PLANNING CONSULTATIONS

07.02 **PRE-APPLICATION PROCESS**

07.03 PRE APPLICATION 01 (3RD NOVEMBER 2022)

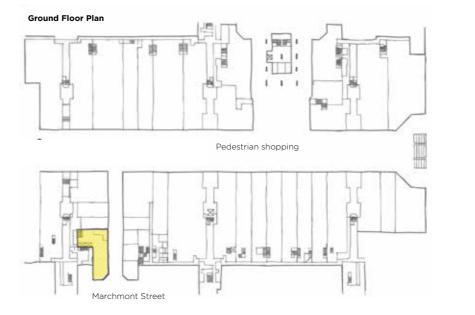
EXISTING SLAB - The officers queried whether the existing concrete floor could be kept rather than removing and putting in a new one. Conservation officer emphasised that Whole Life Carbon and Circular Economy are important considerations and they are keen to reduce demolition as far as possible. Queries were also raised around whether the removal of the existing slab would represent a significant loss of historic fabric.

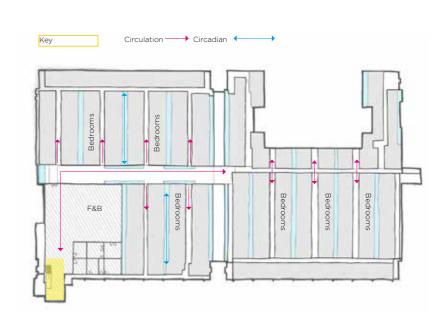
CAR PARK - Officers questioned what level of parking provision would be retained and the cycle parking strategy. Axiom noted that circa 100 spaces would be retained for Waitrose and that the cycle parking strategy for the development was still to be developed. Axiom noted that servicing was proposed to take place off street via the existing service route.

Plaza level - Entrance at Boots Unit

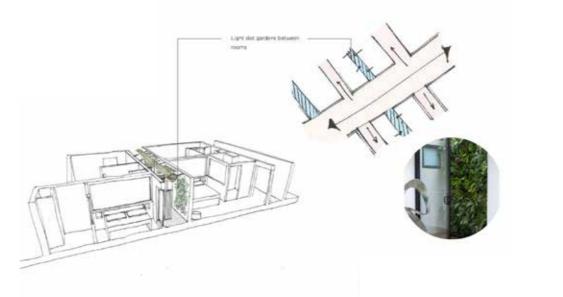
ENTRANCE - Officers raised concern about the removal of Boots as an anchor retail unit. They also gueried whether a different unit could provide the hotel entrance that already has a basement.

Structural strategy sketch proposing the demolition of the existing UB slab/creation of the new slab and strengthening of the existing columns.

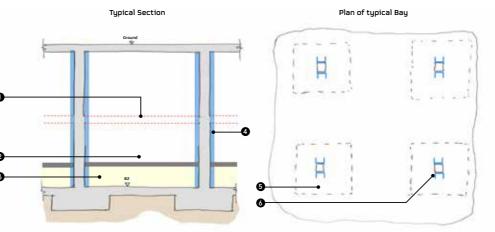
- Conservation officer queried for a long term strategy on repair and maintenance of the existing listed fabric and the need to be an ongoing plan/agreement.
- Conservation officer queried further details on the strengthening of the columns
- Conservation officer was keen to consider PVs on the roof if they were not visible in long views
- Conservation officer was keen to reuse the existing ducts/chimney's for ventilation purposes
